MEMORANDUM

SUBJECT: Mandatory Referral No 10702-MCPS-1
Cannon Road Elementary School Modernization Project,
901 Cannon Road, Silver Spring near the Intersection of Randolph Road and New
Hampshire Avenue Zone: R-90 White Oak Master Plan.

SUBJECT: Cannon Road Elementary Park/School Mandatory Referral – MR # 10702-MCPS-1

ATTACHMENT B

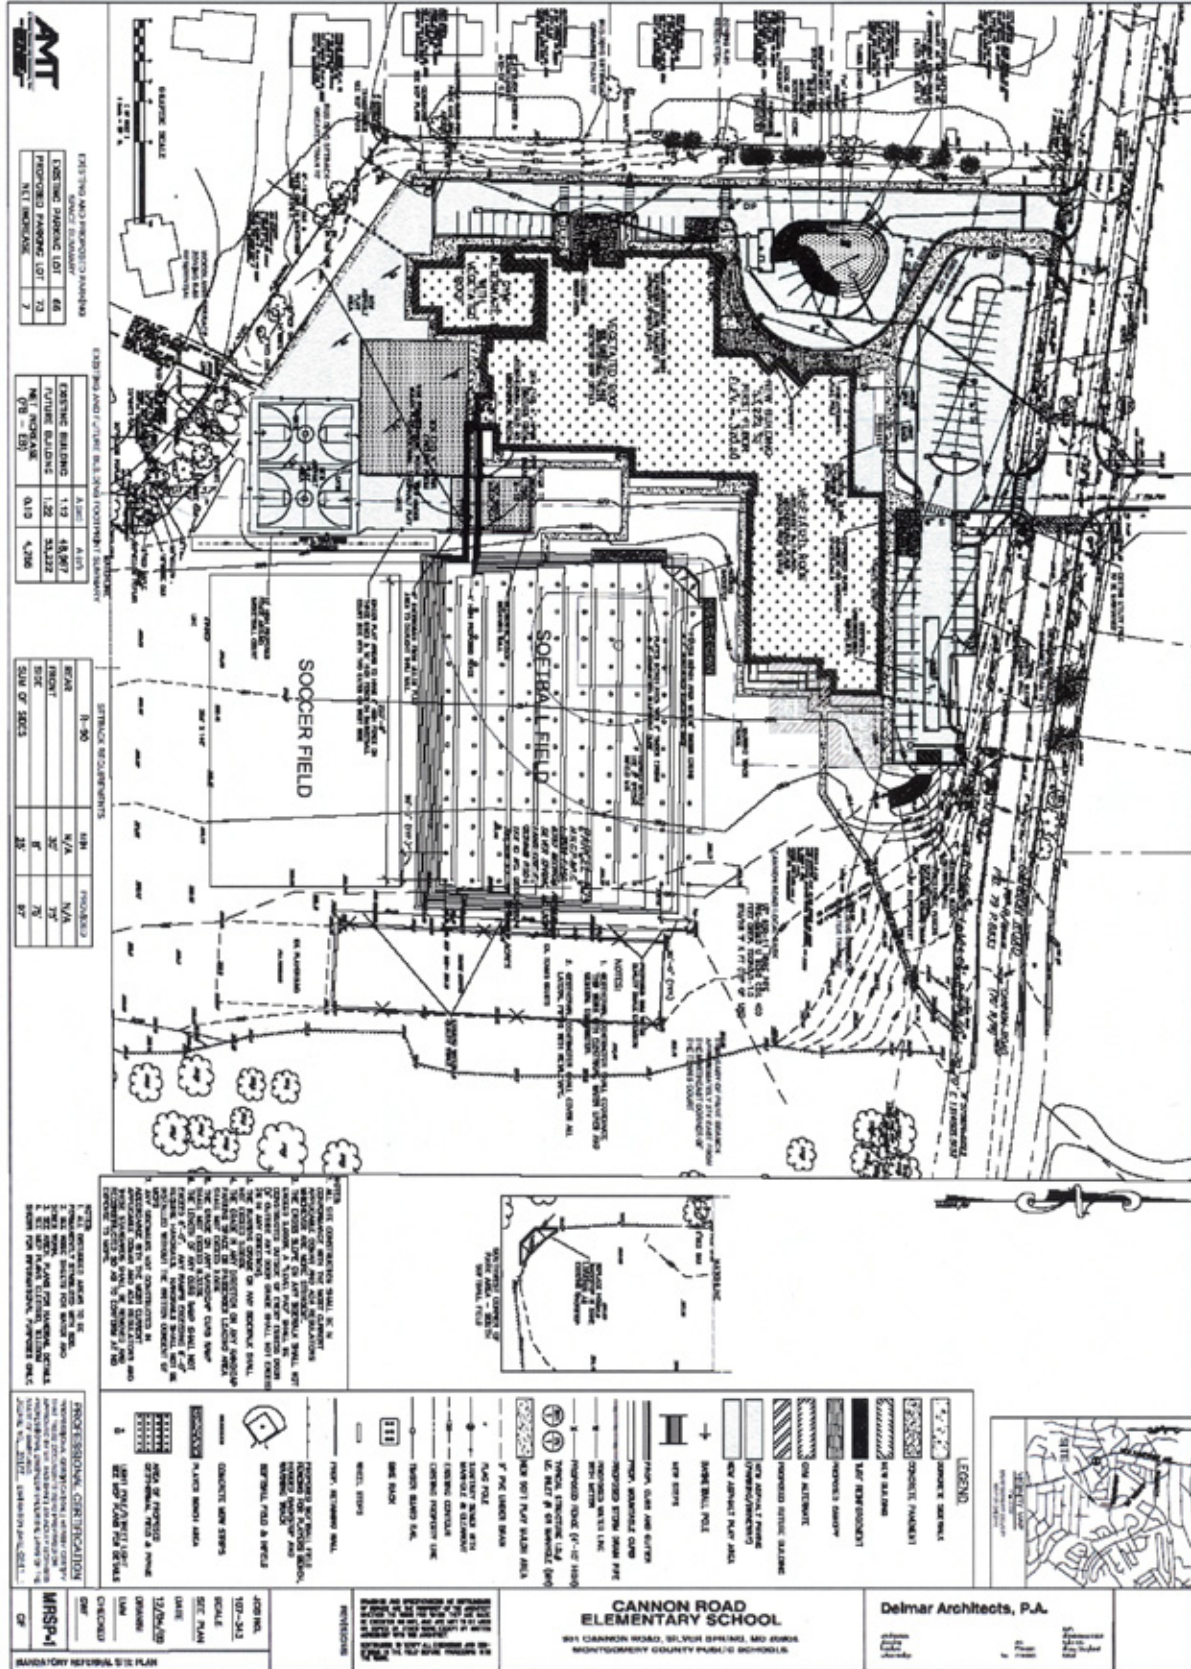
A component of reconstructing the school site consists of geothermal well heating and cooling technology. The 120 wells will be drilled horizontally underground approximately 400 feet deep and will be located underneath Softball Field Number 1 at Cannon Road Local Parkas illustrated in Attachment B "MRSP-1" dated 12/04/2009. Although the technology is not new to Montgomery County Public School (MCPS) sites, it will be a first geothermal well field located on parkland. The invasiveness of installing the technology will require the entire park to be closed during the well drilling, installation, and field restoration period. Park closure is due to intense construction activity in a tight space and concerns about lack of adequate access for maintenance, public safety and policing.

- Parks authorizes installation of approximately 120 geothermal heat pumps (vertical ground loop system) on Softball Field Number 1.
- Parks authorizes construction of an infiltration trench and retaining wall located adjacent and just east of the basketball courts.

- Parks will require that the Park Construction Permit issuance include an easement requirement that delineates the location, and outlines maintenance and replacement responsibilities of the geothermal wells, retaining wall and infiltration trench.

LSP-1
 LANDSCAPE PLAN
 JOB NO. 20-001
 SCALE 1/8" = 1'-0"
 DATE 12/05/20
 DRAWN BY [Name]
 CHECKED BY [Name]
 APPROVED BY [Name]

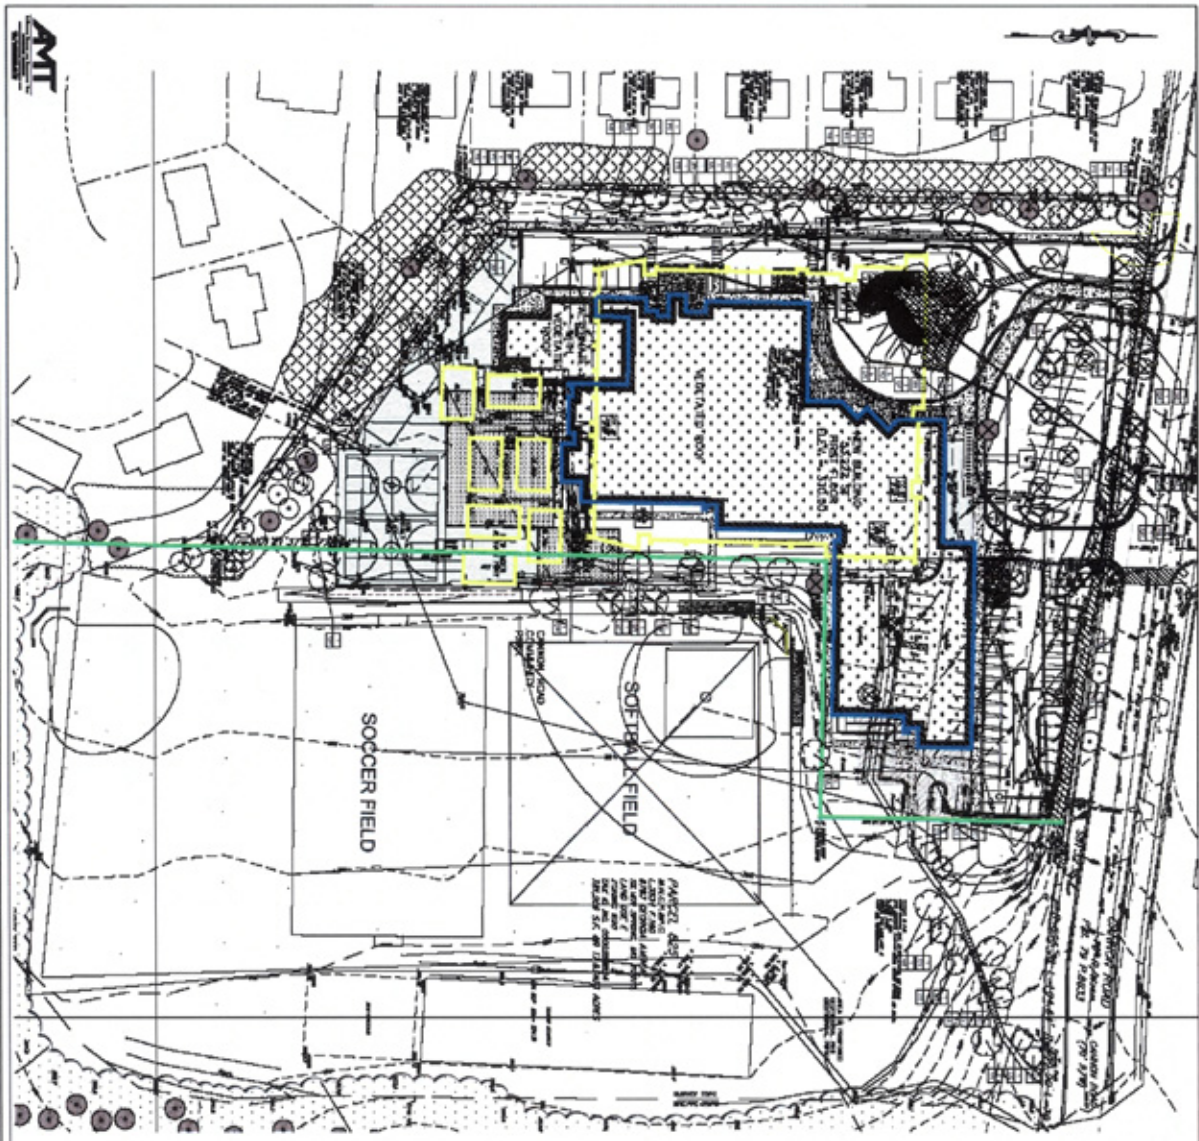
- On Softball Field Number 1 (per sheet LSP-1 -Attachment B), eliminate fencing beyond player bench area.
- Sufficient time must be provided for knitting in new turf and infield restoration before field is re-opened for permitted public use.

The following comments are in response to submittal labeled "LSP -1" Dated 12/4 2009 and referenced as Attachment C.

- Parks authorizes MCPS to remove one 42 inch Willow Oak Tree at the Northwest corner of Park property adjacent to the existing building and replace with inch for inch mitigation at agreed to locations within the Cannon Road Local Park property.
- Twelve 3.5 inch caliper trees should be planted onsite for mitigation.
- Trees proposed for mitigation planting should not be located along walkway to Cannon Road. This will ensure good site visibility consistent with Crime Prevention through Environmental design (CPTED) principles.
- Nine trees should be planted as shown behind northern softball field along 3rd base line and first base line.

- The remaining 3 trees should be planted along the eastern forest edge north of tennis courts.
- Between the building and Softball Field Number 1, change the two Armstrong Red Maples to Willow Oak, which will be more tolerant of difficult soil conditions.
- Plants must be installed per M-NCPPC Plant Installation Specifications and Details which include an inspection pre planting of plant materials by M-NCPPC Horticulturist
- Trees must include a one year warranty and be provided with aftercare during the growing season. Aftercare must include watering for 26 weeks during the growing season. Each tree shall receive 30 gallons of water per week (based on the 10 gallons per caliper inch formula).
- Upon one year warranty inspection, trees shall be de-staked and dead and unacceptable plant material replaced for acceptance.
